TMI-18-038

March 19, 2018

Three Mile Island Nuclear Station, Unit 1
Renewed Facility Operating License No. DPR-50
NRC Docket No. 50-289

Subject: License Amendment Request - Proposed Changes to the Three Mile Island Emergency Plan for Post-Shutdown and Permanently Defueled Condition

TABLE TMI B-1: Minimum Staffing Requirements for TMI Station (Cont'd)

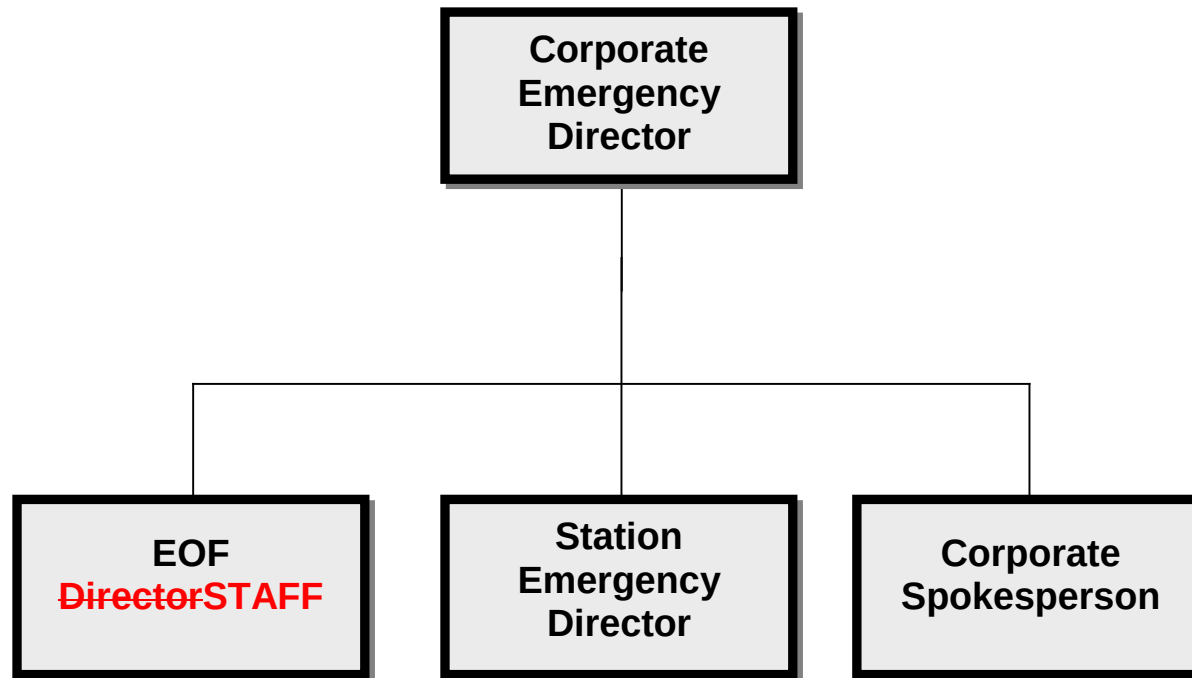
The proposed changes to TMI Emergency Plan, EP-TM-1000, Table TMI B-1, "Minimum Staffing Requirements for TMI Station," eliminates six (6) on-shift positions from the present Emergency Plan staffing levels. The eliminated positions include the following on-shift positions:

Proposed revisions would eliminate nine (9) Minimum Staff positions as shown in the Table 2-1 "TMI Minimum Staff Positions" below. In addition, a number of positions currently assigned to as Minimum Staff were evaluated as not required to perform Emergency Planning Functions nor be required to activate their respective Emergency Response Facilities. These positions are being designated as full augmentation positions.

Figure TMI B-1a: Exelon Overall ERO Command Structure

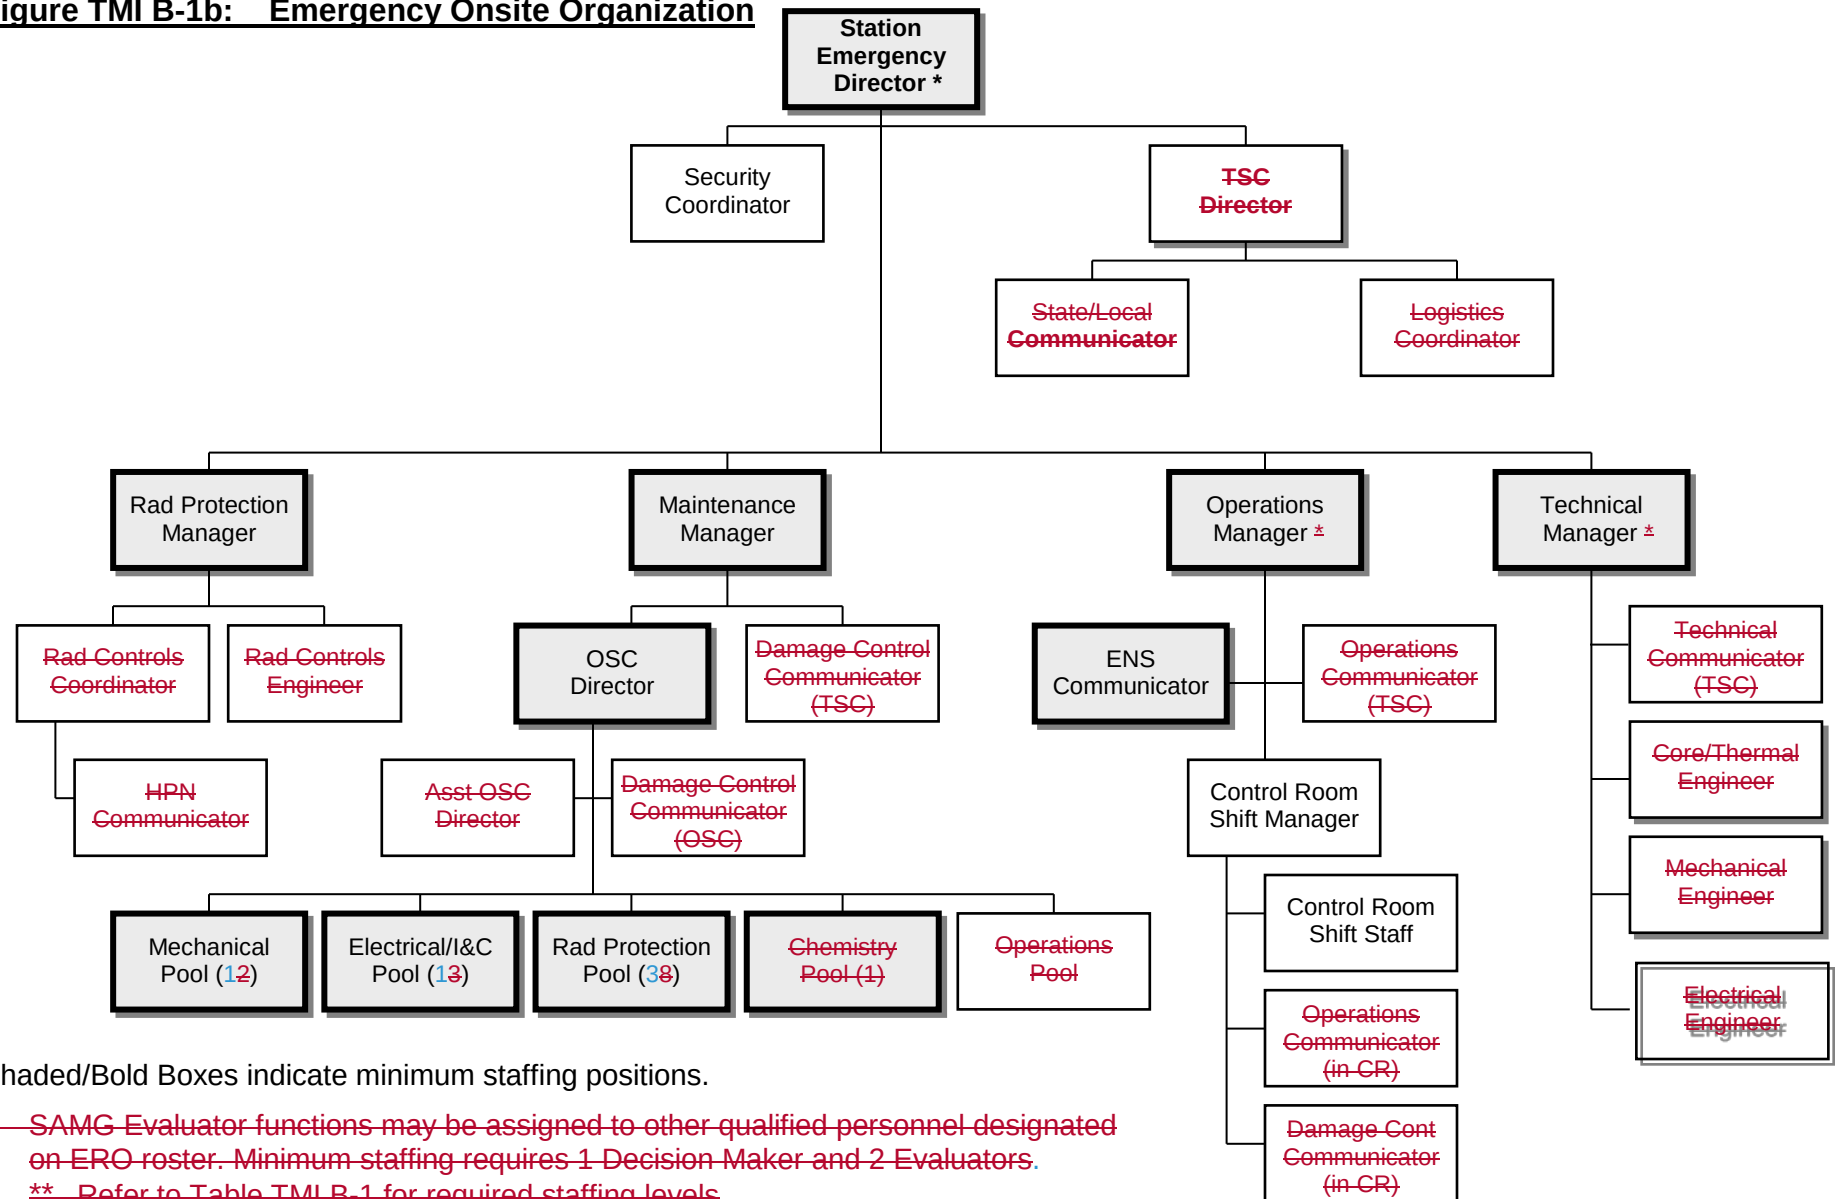
Emergency Plan Section	Current Wording	Proposed Wording	Reason for Change
EP-TM-1000 Part II Figure B-1a	<u>Figure B-1a: Exelon Overall ERO Command Structure</u> Corporate Emergency Director EOF Director Station Emergency Director Corporate Spokesperson	<u>Figure B-1a: Exelon Overall ERO Command Structure</u> Corporate Emergency Director EOF ~~Director~~Staff Station Emergency Director Corporate Spokesperson	Changes to Figure B-1a reflect the changes to the Three Mile Island ERO discussed in this Attachment as well as Attachment 1 and Attachment 4.
EP-TM-1000 Part II Figure B-1b	Figure B-1b Emergency Onsite Organization Station Emergency Director* Security Coordinator TSC Director State / Local Communicator Logistics Coordinator Rad Protection Manager Maintenance Manager Operations Manager* Technical Manager* Rad Controls Coordinator Rad Controls Engineer HPN Communicator ENS Communicator TSC Operations Communicator TSC Technical Communicator Core / Thermal Engineer Mechanical Engineer Electrical Engineer Control Room Shift Manager Control Room Shift Staff CR Operations Communicator CR Damage Cont Communicator TSC Damage Cont Communicator OSC Director Assistant OSC Director OSC Damage Cont Communicator Mechanical Pool (2) Electrical/I&C Pool (3) Rad Protection Pool (8) Chemistry Pool (1) Operations Pool Shaded/Bold Boxes indicate minimum staffing positions.	Figure B-1b Emergency Onsite Organization Station Emergency Director* Security Coordinator ~~TSC Director~~ ~~State / Local Communicator~~ ~~Logistics Coordinator~~ Rad Protection Manager Maintenance Manager Operations Manager* Technical Manager* ~~Rad Controls Coordinator~~ ~~Rad Controls Engineer~~ ~~HPN Communicator~~ ENS Communicator ~~TSC Operations Communicator~~ ~~TSC Technical Communicator~~ ~~Core / Thermal Engineer~~ ~~Mechanical Engineer~~ ~~Electrical Engineer~~ Control Room Shift Manager Control Room Shift Staff ~~CR Operations Communicator~~ ~~CR Damage Cont Communicator~~ ~~TSC Damage Cont Communicator~~ OSC Director ~~Assistant OSC Director~~ ~~OSC Damage Cont Communicator~~ Mechanical Pool (12) Electrical/I&C Pool (13) Rad Protection Pool (38) ~~Chemistry Pool (1)~~ ~~Operations Pool~~ Shaded/Bold Boxes indicate minimum staffing positions.	Changes to Figure B-1b reflect the changes to the Three Mile Island ERO discussed in this Attachment as well as Attachment 1 and Attachment 4. The note "SAMG functions may be assigned to other qualified personnel. Minimum staffing requires 1 Decision-Maker and 2 Evaluators" is deleted from the Figure. SAMG does not apply and evaluators are no longer needed for a permanently shutdown and defueled condition.
